**HIGHLANDS COUNTY  
BOARD OF COUNTY COMMISSIONERS  
(HCBCC)  
PURCHASING DIVISION**

BID NO. ITB 20-009

ADDENDUM No. 4

Project: New Public Safety Administration Office

# **DRYWELL DETAIL**

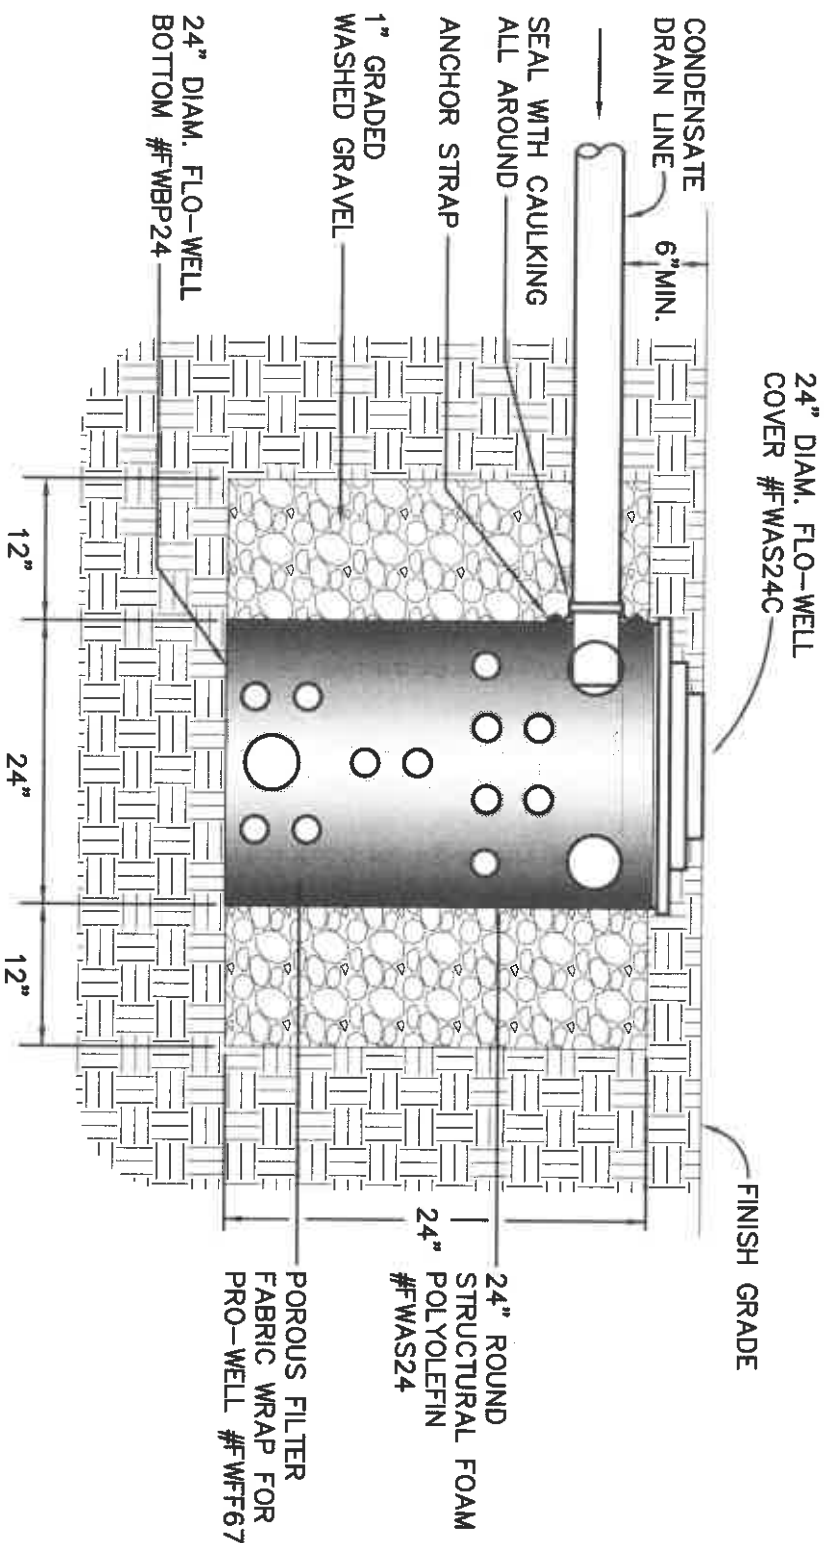
1. To clarify, all new walls surrounding Date room (143) shall extend to the roof deck and be sealed to the existing roof insulation/decking.
2. See the attached drywell detail referenced on Sheet A101.

5. Sheet A101, Note 1514 suggests a detail for the New Drywell is located in the Mechanical Plans, but none can be found.

**ANSWER:** Refer to detail of drywell – attached to this addendum. Note on sheet P201 – redirect the new 3" condensate line from the mechanical loft to the east and connect to the new drywell.

**NOTE:** LID SHALL HAVE HOLE IN TOP FOR VENTING & ACCESS PURPOSES. SOLID COVER WILL NOT BE ACCEPTABLE.
